Access Compliance Report

Public Rights-of-Way

(Curb Ramps)

Intersection ID: 28101	Main Street: OLYMPIC CLUB DR	Cross Street: PINE VALLEY CLUB DR	Location: SW
ADA ID: B071AB3B8D8A	Ramp Type: PerpDiag	Initial Pass/Fail: Fail	Overall Compliance: No
Codes/Mitigation Info/Possible Solution			Severity Score: 25
			Field Measurements/Component Compliance

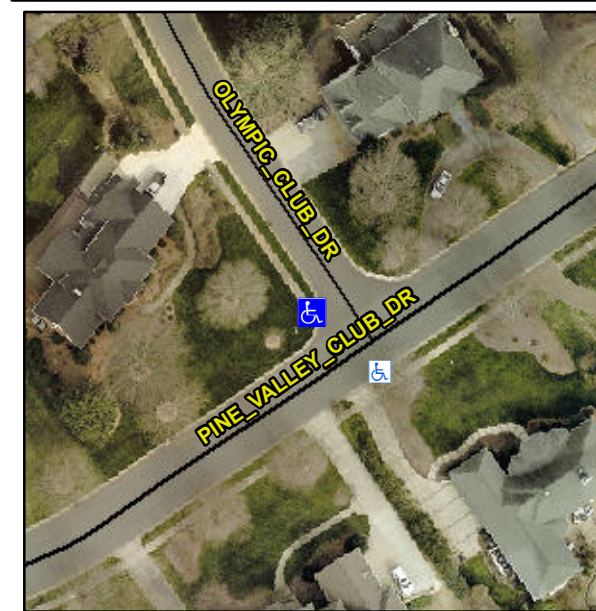
Not Found, R304.2.2, R304.5.3

Compliance	Description	Data	Compliance	Description	Data
N/A	Ramp Length (in)	46.0	No	Ramp Slope (%)	11.1
Yes	Ramp Width (in)	48.0	No	Ramp XSlope (%)	5.6
N/A	Flare Type LT	N/A	N/A	Flare Type RT	N/A
N/A	Flare Slope LT (%)	N/A	N/A	Flare Slope RT (%)	N/A
N/A	Flare Traversable LT?	N/A	N/A	Flare Traversable RT?	N/A
N/A	Landing Length (in)	N/A	N/A	DWS Provided?	N/A
N/A	Landing Width (in)	N/A	N/A	DWS Contrast?	N/A
N/A	Landing Slope (%)	N/A	N/A	DWS Length (in)	N/A
N/A	Landing X Slope (%)	N/A	N/A	DWS Full Width?	N/A
N/A	Landing Curb? (Y/N)	N/A	N/A	DWS Offset (in)	N/A
N/A	Shared Landing?	N/A			
N/A	Gutter Ponding?	N/A	N/A	Gutter Slope (%)	N/A
N/A	Gutter Lip Ht (in)	N/A	N/A	Gutter X Slope (%)	N/A
N/A	Painted X Walk1?	No	N/A	Painted X Walk2?	No
	X Walk 1 Direction	To SE		X Walk 2 Direction	To NE
N/A	X Walk 1 Width (in)	N/A	N/A	X Walk 2 Width (in)	N/A
	X Walk 1 Slope (%)	2.4		X Walk 2 Slope (%)	1.3
	X Walk 1 X Slope (%)	2.6		X Walk 2 X Slope (%)	2.1

Remove & Replace Curb Ramp With Two New Directional Ramps or Equivalent.
